ADDENDUM NUMBER 2

Dated: November 15th, 2019

**UPPER BROADWAY BIKE LANES PROJECT
(INCLUDING UPPER BROADWAY PEDESTRIAN CONNECTION)
PROJECT NO. CML – 5015 (027 & 029)
CIP # 41508
and
UPPER BROADWAY STORM DRAIN REPLACEMENT PROJECT
CIP # 42004**

PROJECT NO.
6884.012
SHEET NO. **C04** OF **C07**

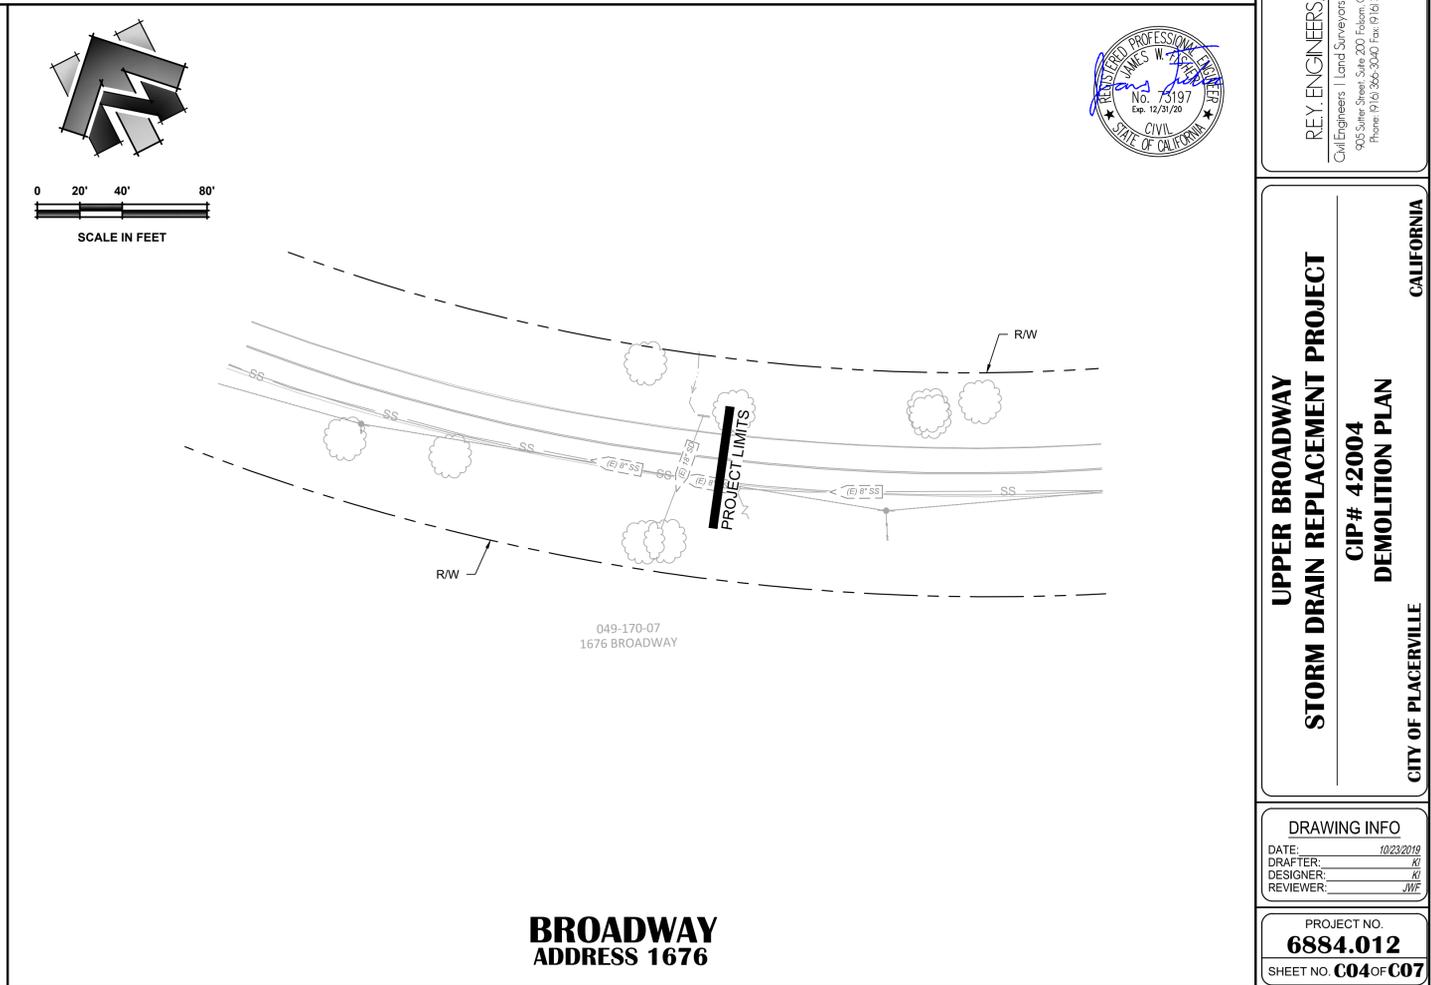
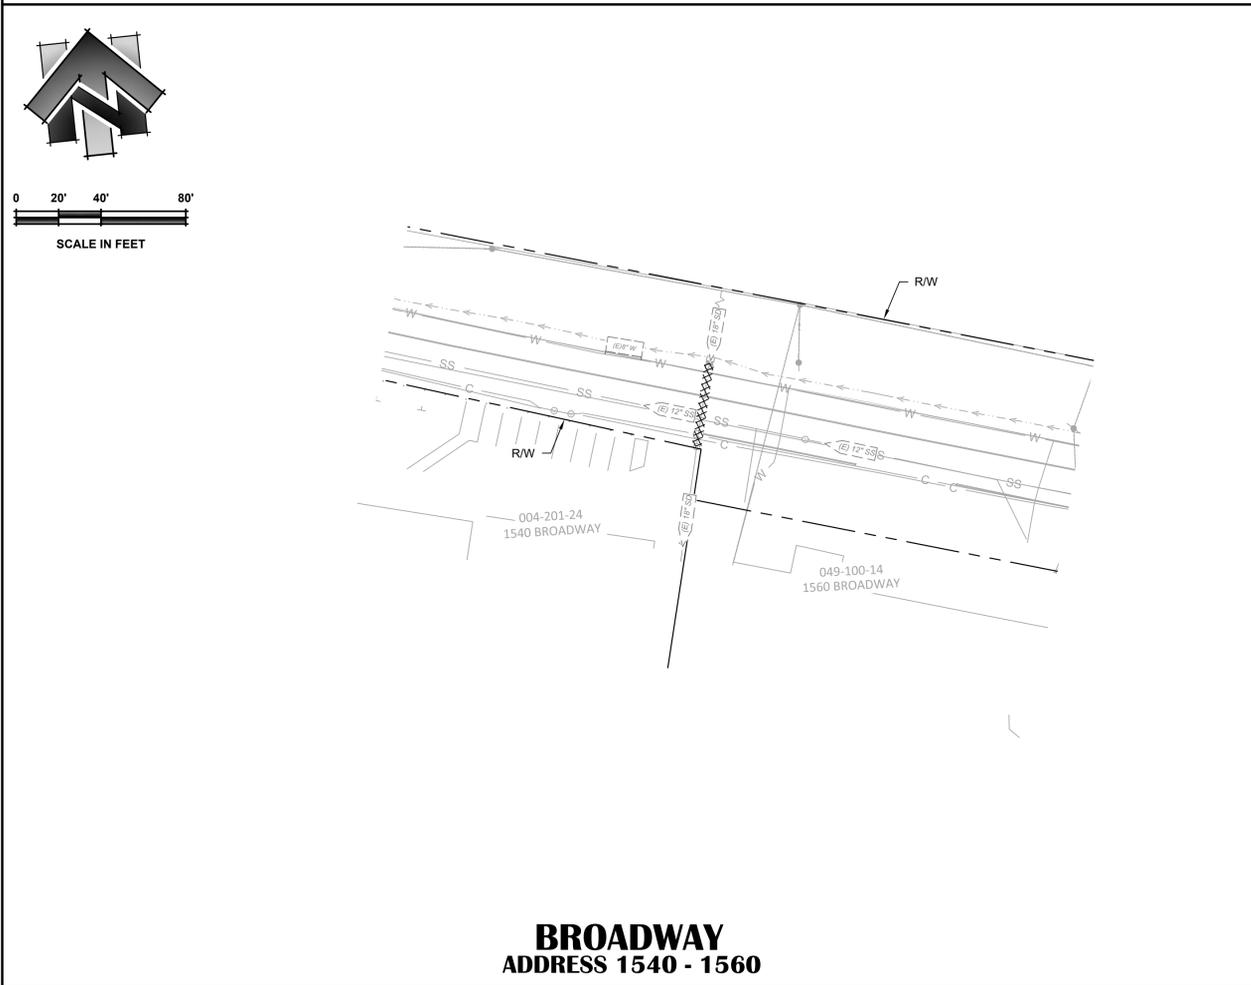
Regarding Plan Sheet C04 of the Upper Broadway Storm Drain Replacement Project Plans. The Remove Storm Drain Pipe shown in the indicated area has been removed from the scope of work. Please see the attached revised plan sheet. Remove Storm Drain Pipe will not occur in this area. The sheet quantity has been updated to reflect the change in scope.

| NO. | REVISION DESCRIPTION | CHECKED BY | DATE |
|-----|--------------------------------|------------|----------|
| 1 | DELETE REMOVE STORM DRAIN PIPE | JWF | 11/15/19 |

PROJECT NO.
6884.003
SHEET NO. **S7** OF **S15**

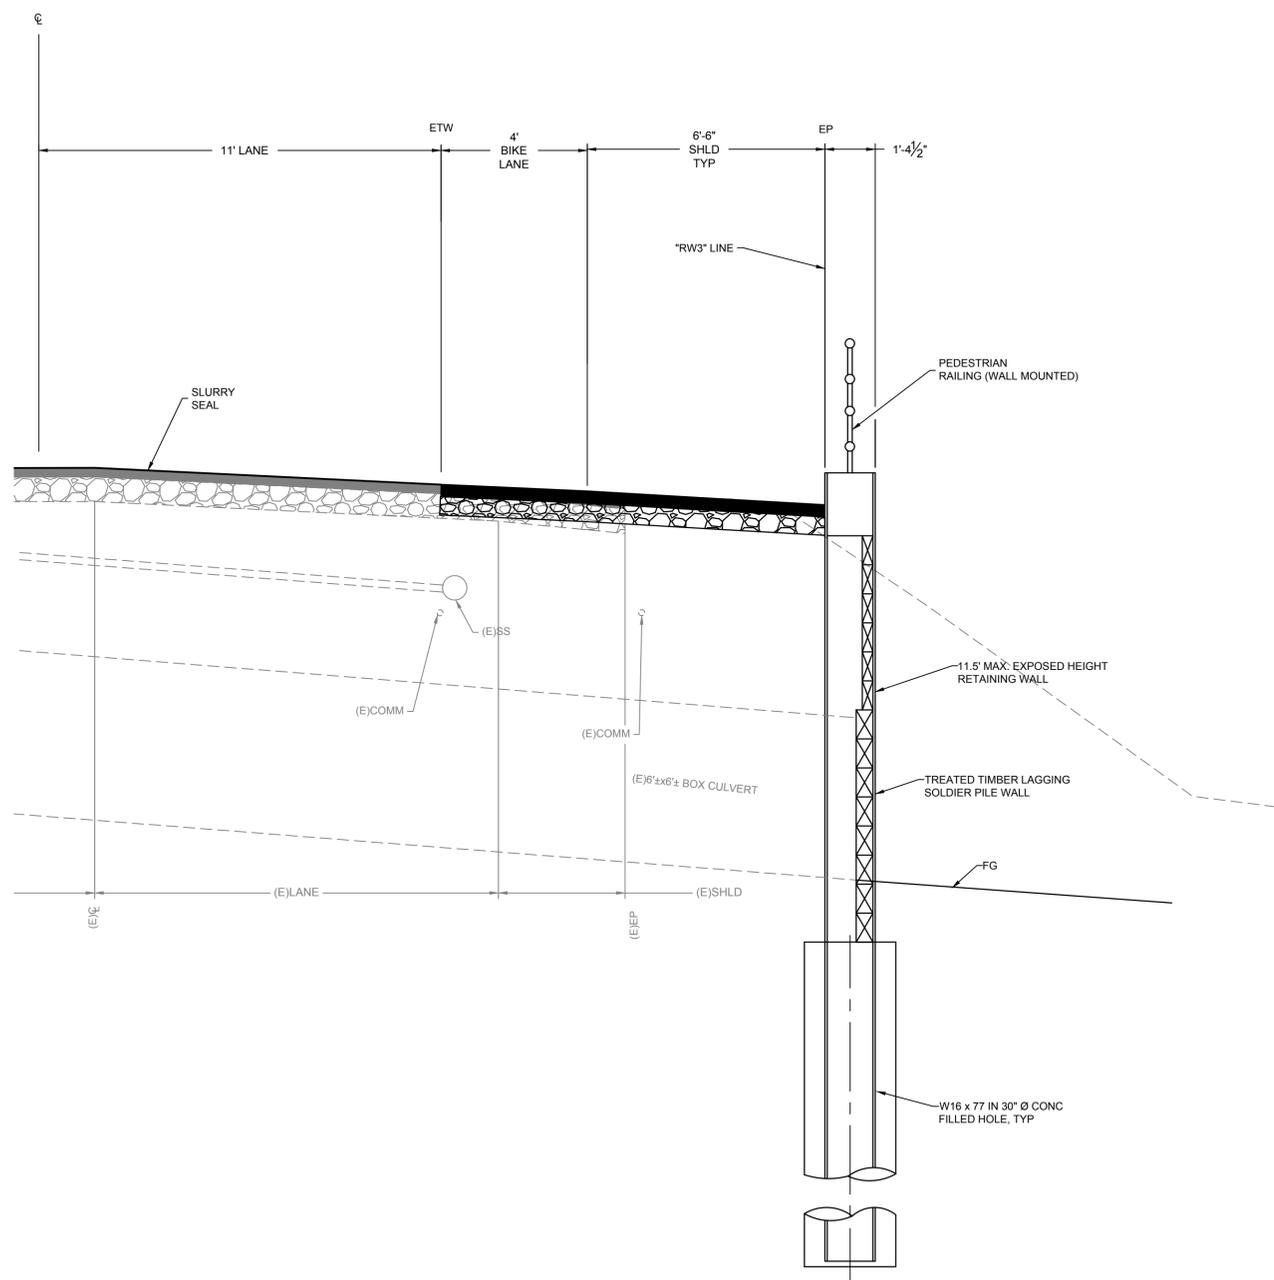
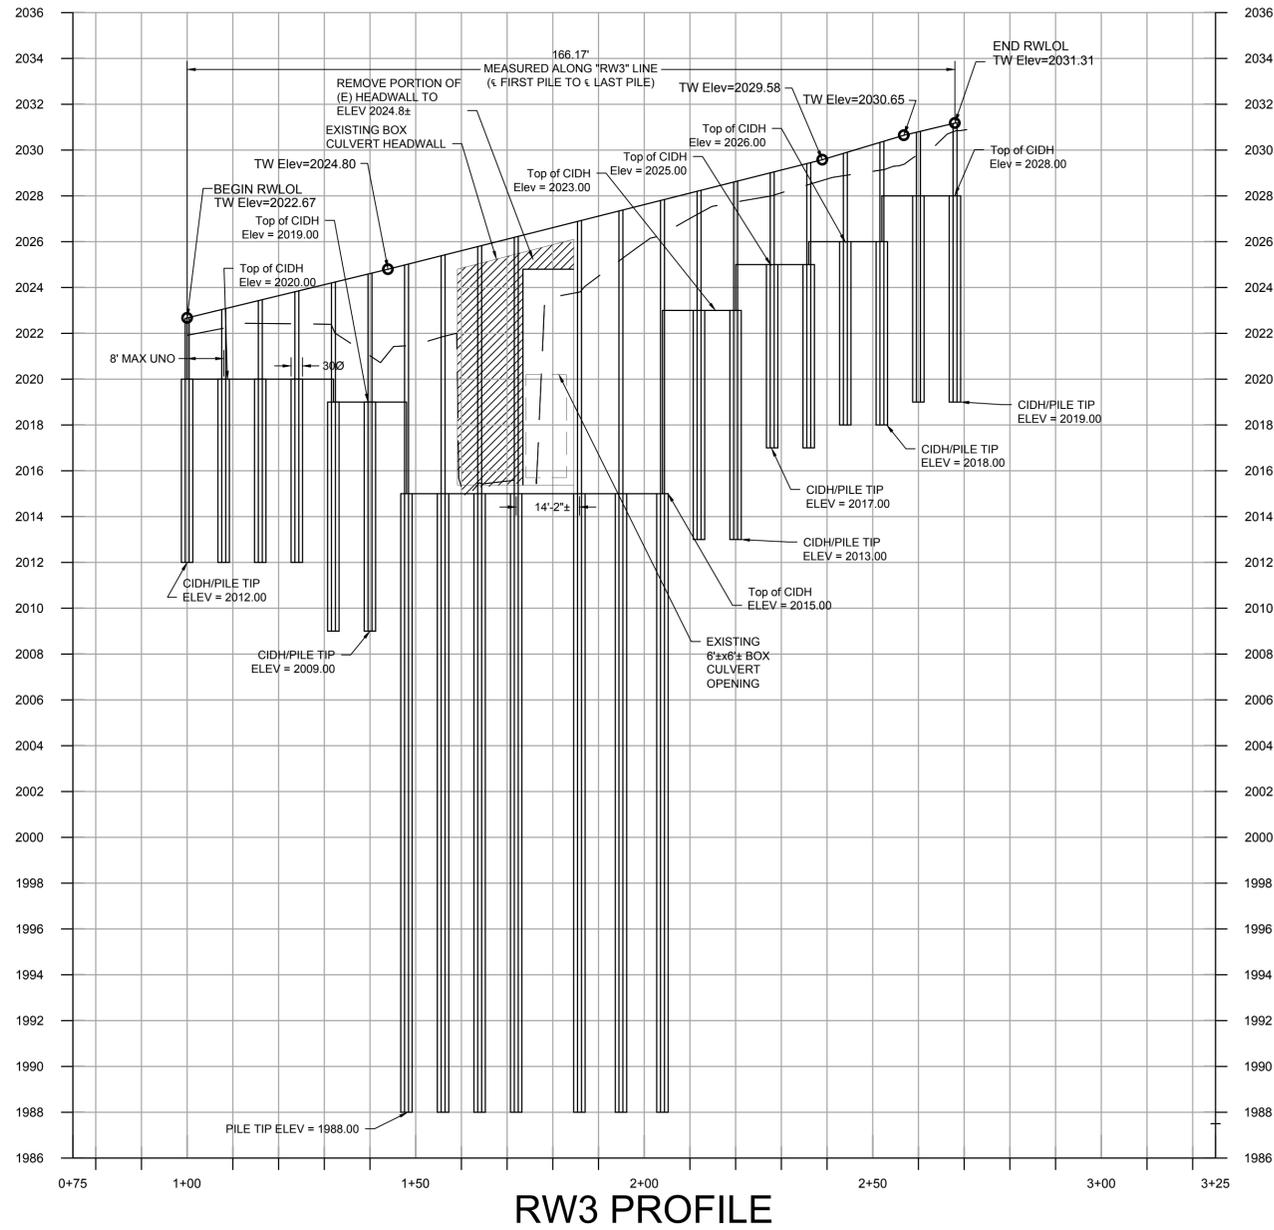
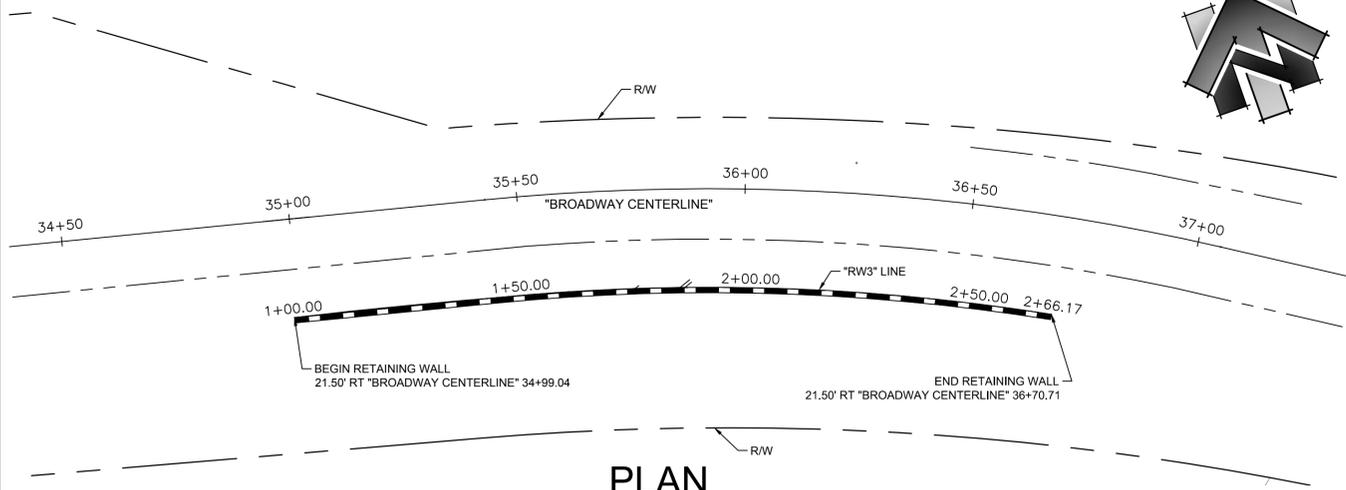
Regarding Plan Sheet S7 of the Upper Broadway Bike Lanes (including Pedestrian Connection) Project Plans. Replace Sheet S7 with the attached revised Sheet S7. Changes made on the revised Sheet S7 include:

- Updated length of retaining wall.
- Corrected elevation listed on the “REMOVE PORTION OF (E) HEADWALL TO ELEV” note.
- Updated piles in profile view to show W19x77 piles extending to the top of wall to fully support the lagging.
- Revised intermediate elevation callouts to read “Top of CIDH Elev =” in profile view.
- Revised bottom elevation callouts to read “CIDH/PILE TIP Elev =” in profile view.
- Revised call out in typical section to call out “Treated” timber lagging.
